# TECHNICAL EVALUATION REPORT

## MASONRY WALL DESIGN

DAVIS-BESSE NUCLEAR POWER STATION UNIT 1

November 27, 1984

BRACES FOR WALLS 3167, 3177, and 3187

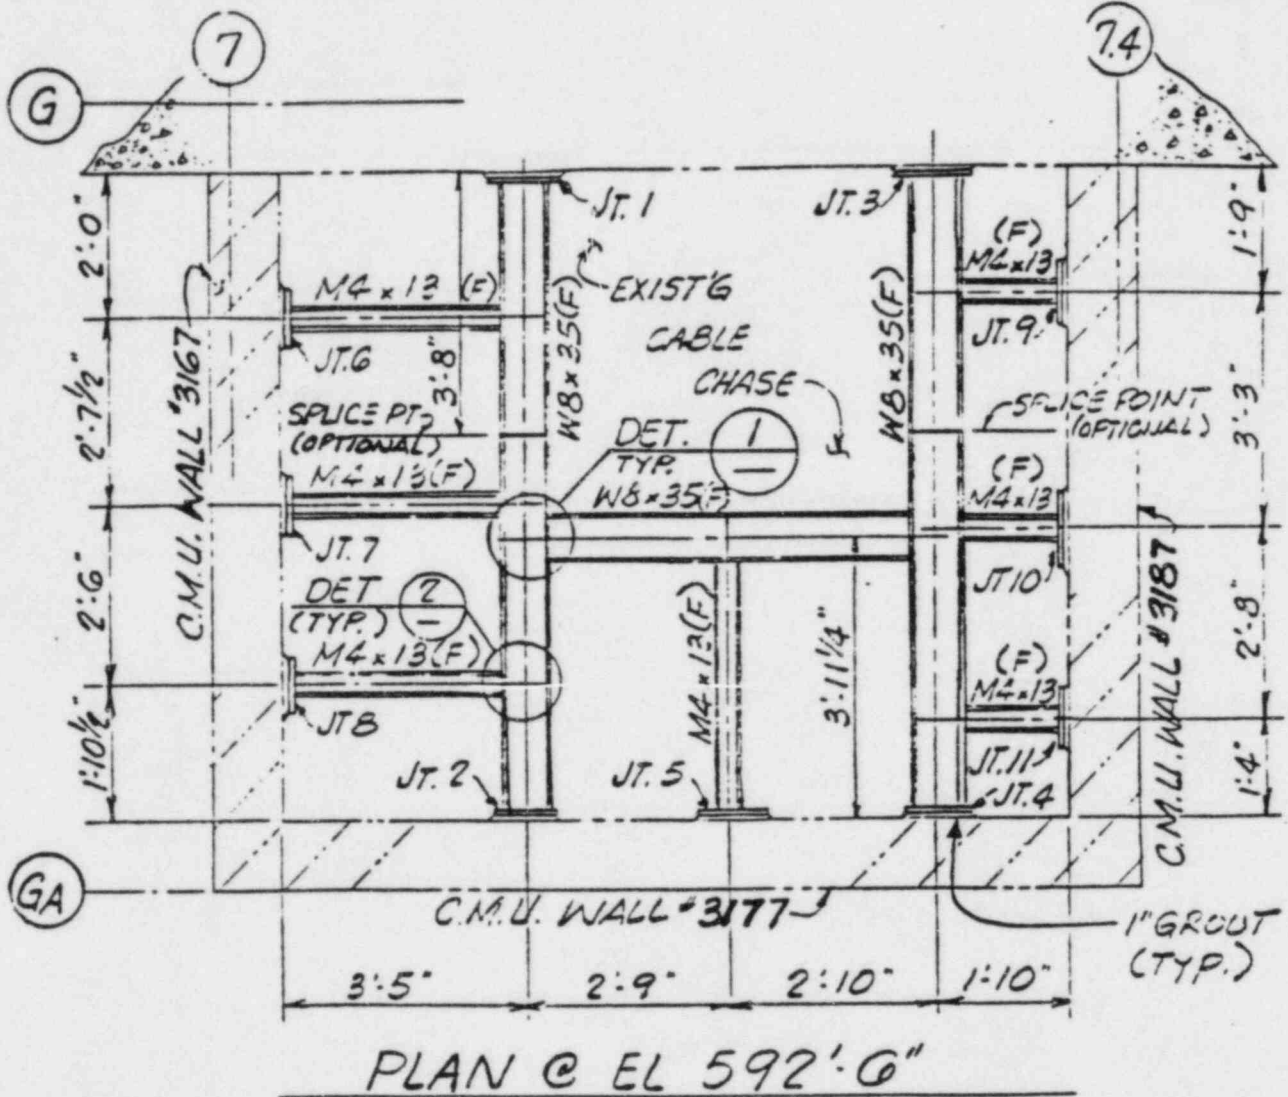
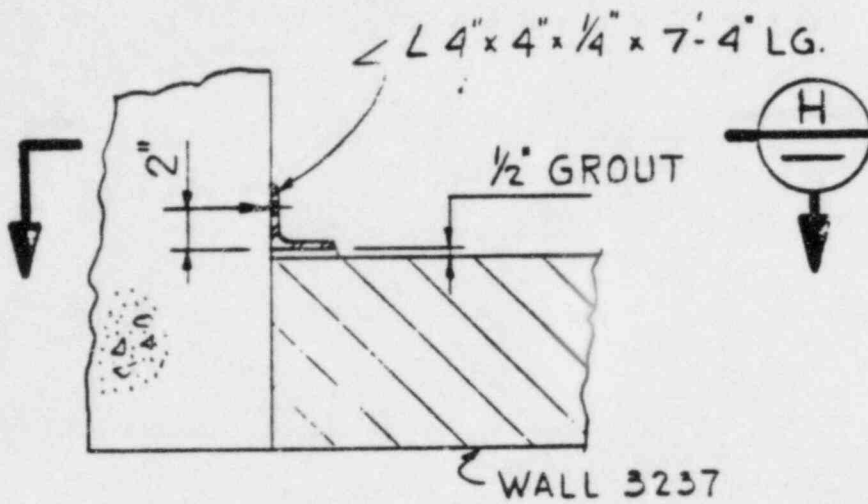
Provide pre-modifications and post-modification calculations for wall No. 3167.

The Licensee provided the requested calculations for wall 3167. Modifications to this wall consisted of steel braces which reduced the wall to a series of shorter spans (see Appendix C for further details). However, even with these modifications, the masonry reinforcement was overstressed in tension, under the working stress criteria. Therefore, the energy balance technique was used, with the modifications, to qualify wall 3167.
